# THE CORRADINO GROUP, INC.

date: September 20, 2023  
to: Jennifer Hofmeister-Drew, AICP, LCAM, Planner III,  
Town of Palm Beach  
from: Eric Czerniejewski, P.E., ENV SP  
subject: Paramount Palm Beach Traffic Review

## MEMORANDUM

The Corradino Group, Inc (Corradino) has been requested to provide a traffic review of the Traffic Impact Evaluation for the redevelopment of the Paramount Theatre located at 139 North County Road in the Town of Palm Beach, Florida. The following are our traffic review comments based on the 09/11/23 resubmittal along with the 09/19/23 KHA supplemental documents.

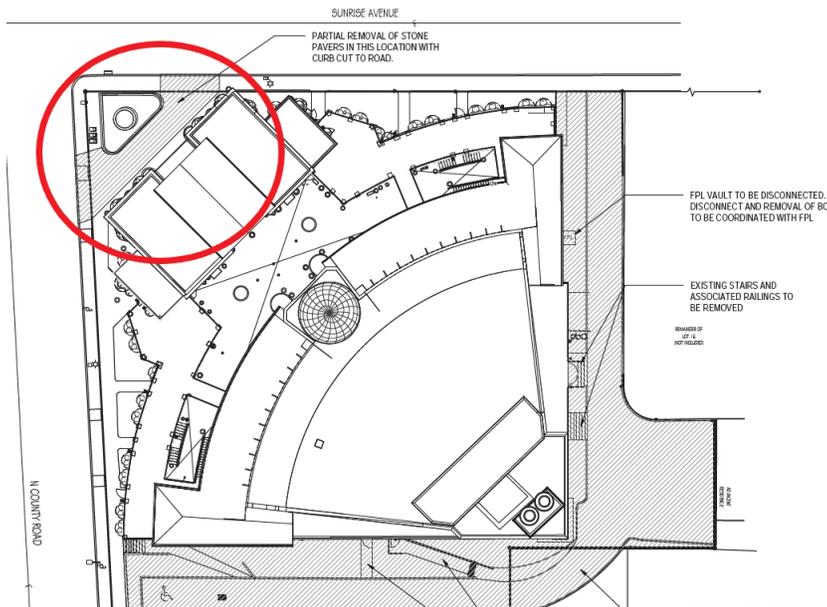
12. Please provide additional narrative that provides the total amount of queuing available from the valet stand to the adjacent road network for both scenarios. Figures 3 and 4 should be updated to denote the total amount of queuing available from the valet stand to the adjacent road network.

**Kimley Horn and Associates, Inc.'s 03/09/23 Response** Additional information is provided in the updated report and Figures 3 and 4 illustrating the queuing available to the adjacent road network. Note that the valet stand for the event space is proposed to be located on North County Road.

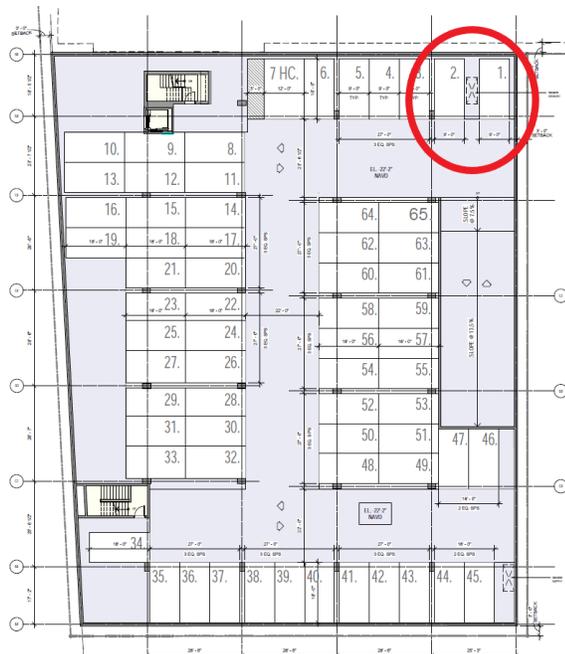
17. Please update the Kimley Horn and Associates, Inc.'s parking study dated 02/28/23 to include the number of parking spaces being provided per the current site plan as outlined in the parking calculation summary provided on site plan sheet A-21.

**Kimley Horn and Associates, Inc.'s 04/18/23 Response:** An updated version of this study has been provided.

**TCG 08/02/23 Response:** Addressed. A condition of approval will be needed to require a parking utilization study of the parking supply of the redeveloped site during a special event and during normal activities after the site is built out within 6 months of opening. A methodology of the parking utilization study should be submitted to the Town of Palm Beach for review and approval prior to commencement of the parking data collection.

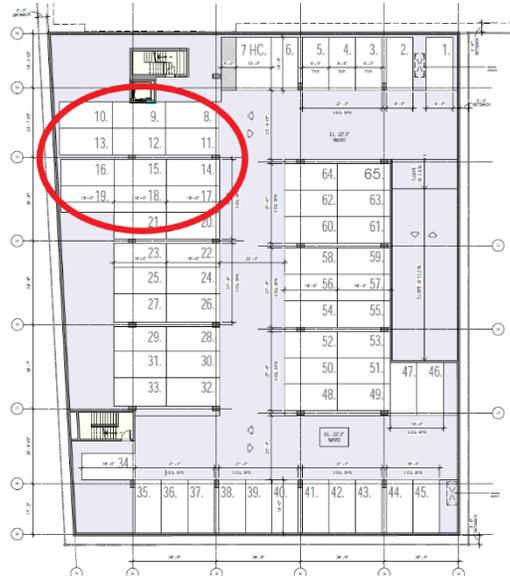
19. Please limit the number of parking spaces that are being proposed at the parking garage ramp locations to improve overall internal traffic circulation. There should be sufficient sight visibility for vehicles backing out of the proposed parking spaces for safe and efficient traffic circulation.

**Kimley Horn and Associates, Inc.'s 04/18/23 Response:** The architect has prepared updated garage parking plans, which have been submitted under separate cover.

**TCG 08/02/23 Response:** Addressed.
